Fiber Cement with EasyTrim - Trim Summary

Project Name: John Grace Arms
Location: 21030 Indian St.
Project No: 99025
Project Address: Southfield, MI 48033
Date: November 06, 2025

Fiber Cement with EasyTrim - Bill Of Quantities

- Drawing reference: **"BULLETIN #1" dated 02.19.2025**
- Estimator assumed that whole wall will be replaced with Fiber Cement Panel, hence, Face Brick and Precast Stone are to be supplied with 5/16" EasyTrim. See page 11.**

Section at Kitchen 2B
D2 A-552
SCALE: 3/8" = 1'-0"

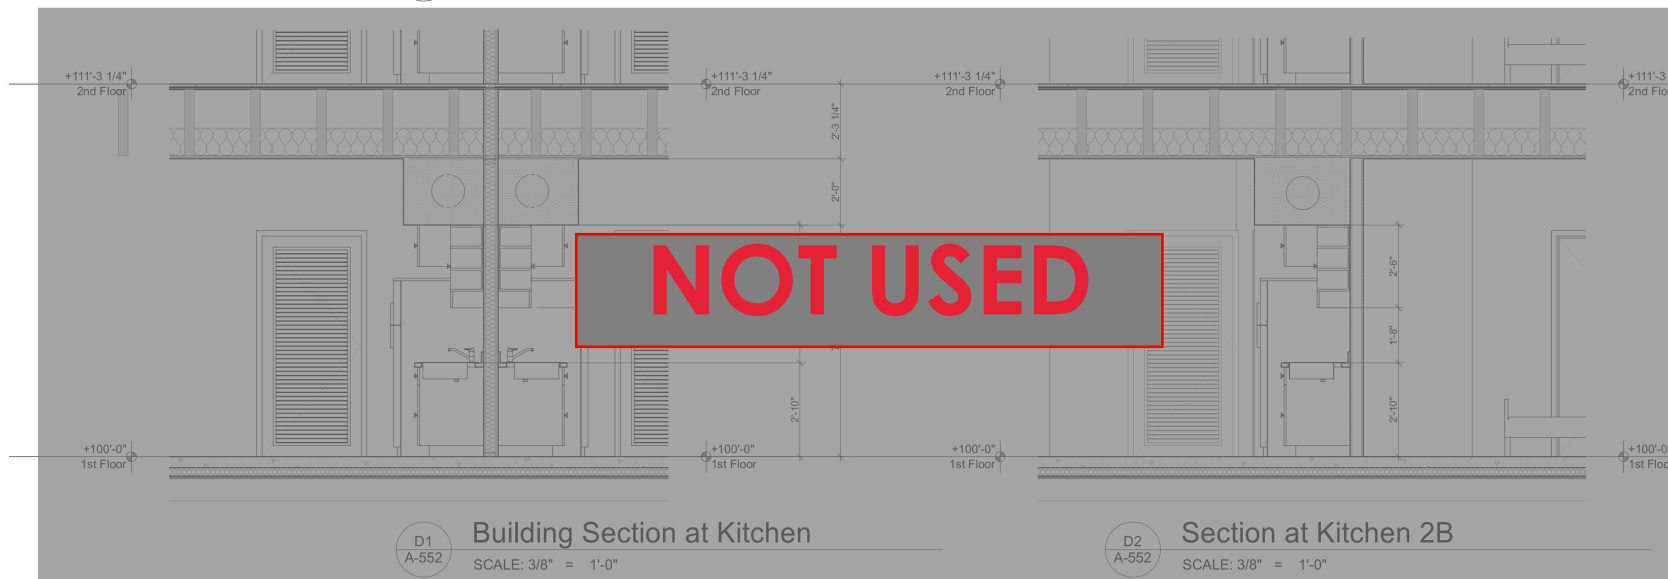
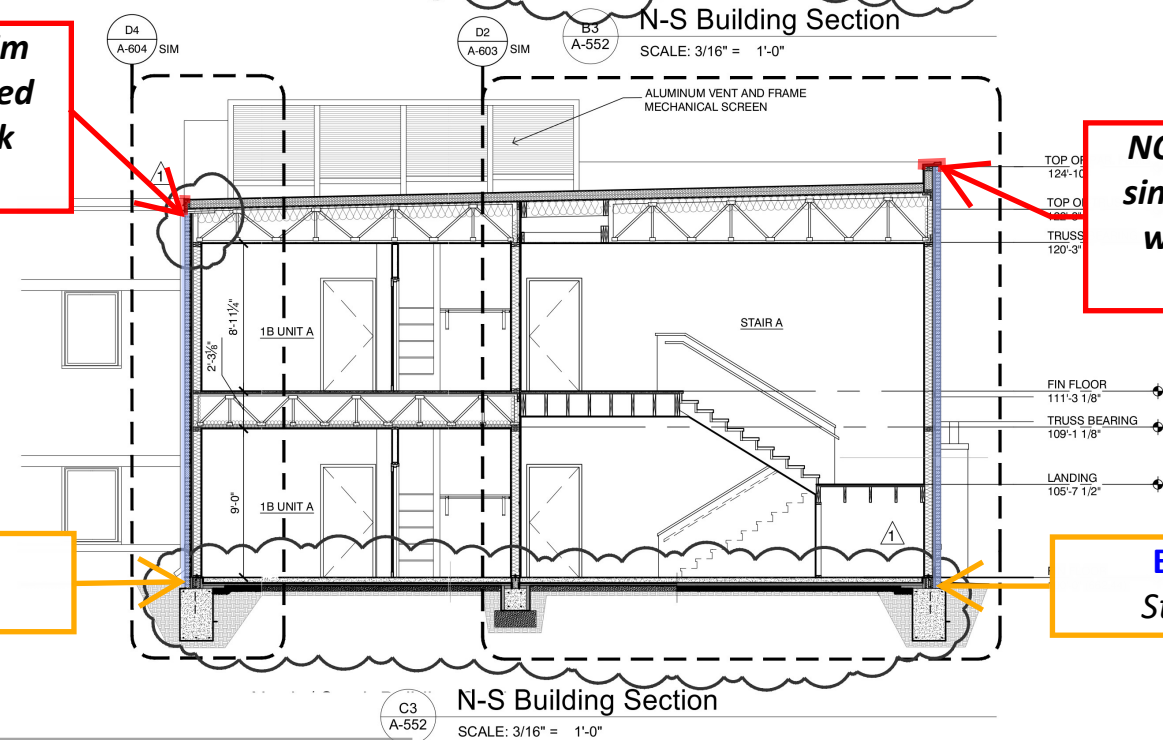
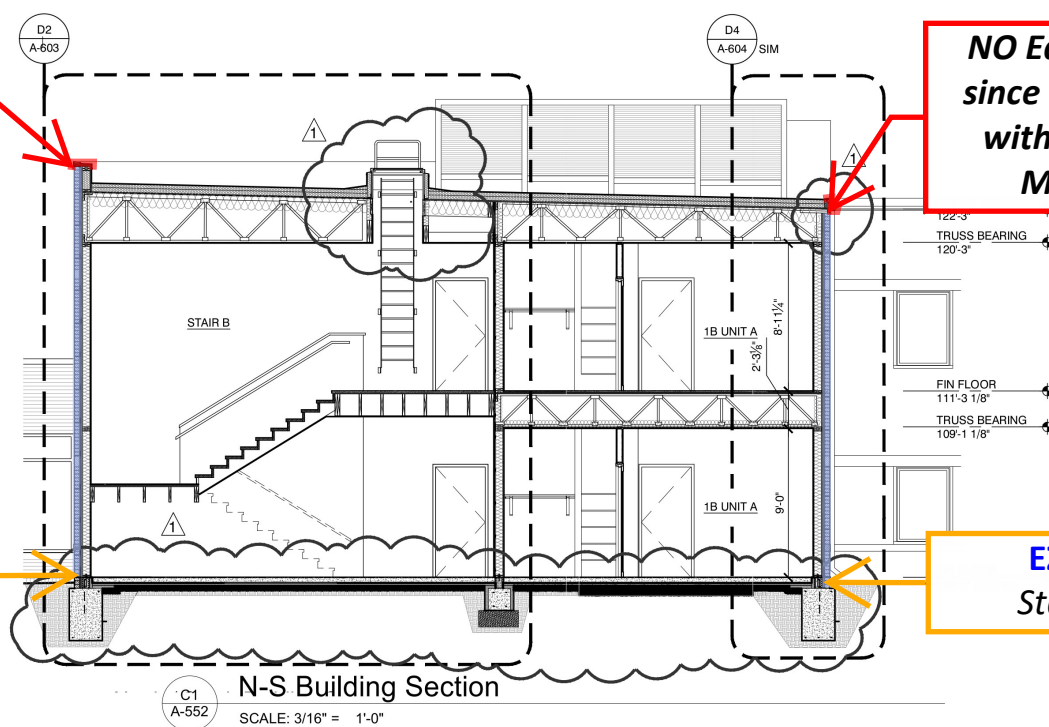
Face Brick will be replaced with Fiber Cement Panel with 5/16" EasyTrim as per client's request.

**NO EasyTrim
since covered
with Metal
Coping**

**EZ 05 + EZ 28
D&W Head**

**EZ 04
Starter**

**EZ 08
D&W Sill**

**NO EasyTrim
since covered
with Break
Metal**
